M9804A-03

Information Only Service Note

M9804A PXIe Vector Network Analyzer

False alarm on self-test failure on firmware revision of A.13.40.02 - DDR3 memory removal

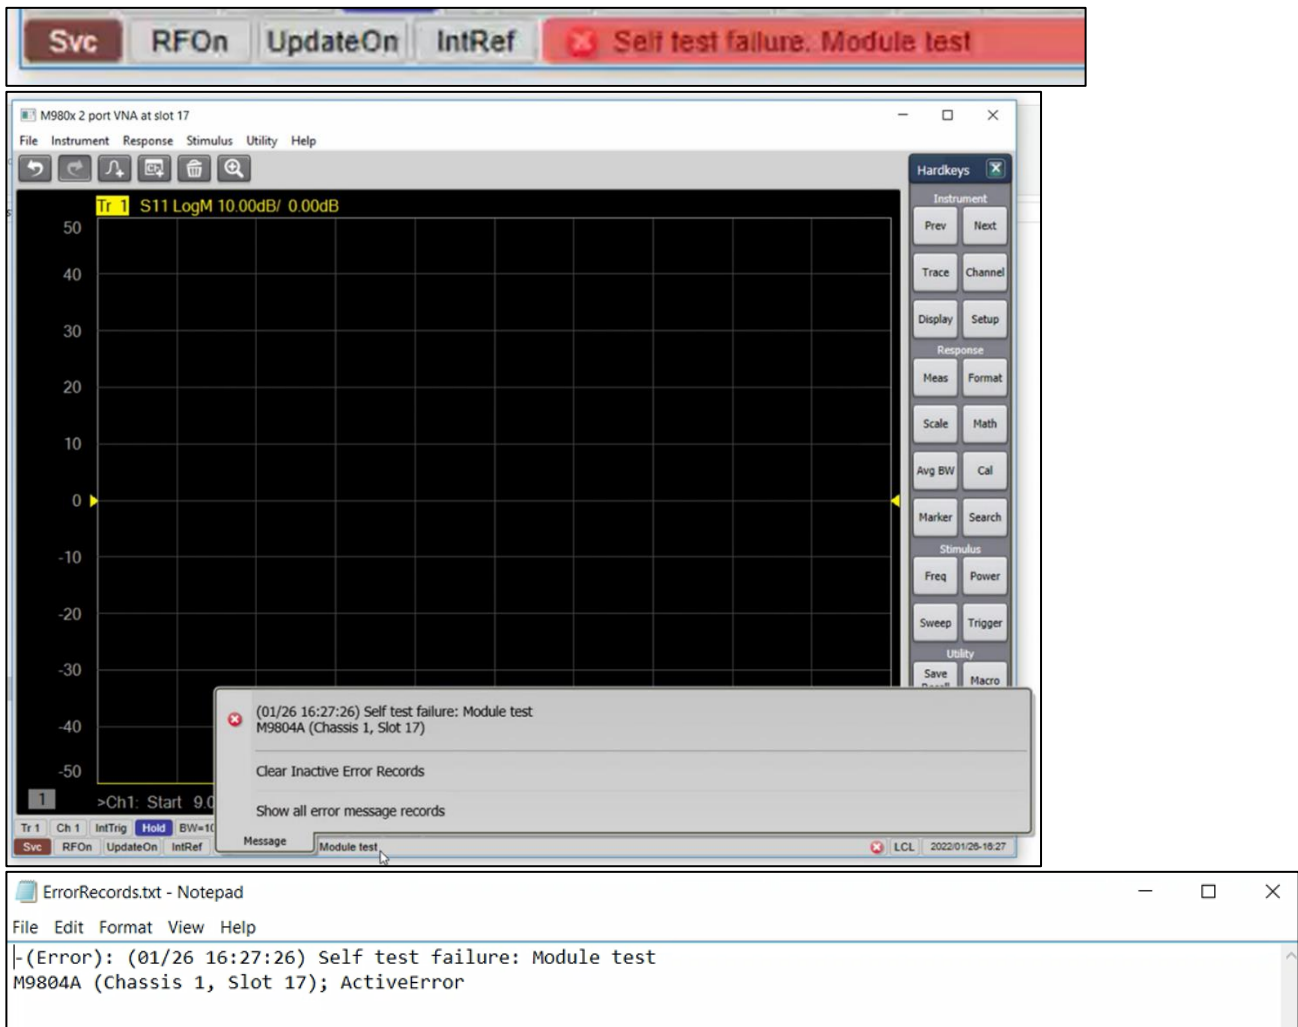
The on board DDR 3 memory in VNA is not in use since its release. With the removal of DDR 3 memory IC on newer M980xA VNA, right after firmware is launched, false alarm (self-test failure) will be reported as shown. This has no impact to VNA performance and specifications.

Similarly, firmware will report a false failure in Operator check. Shown are the error messages example on VNA firmware UI.

For users with firmware revision of A.13.40.02,
Update firmware to revision A.13.70.02 or newer to resolve this false alarm on self-test.
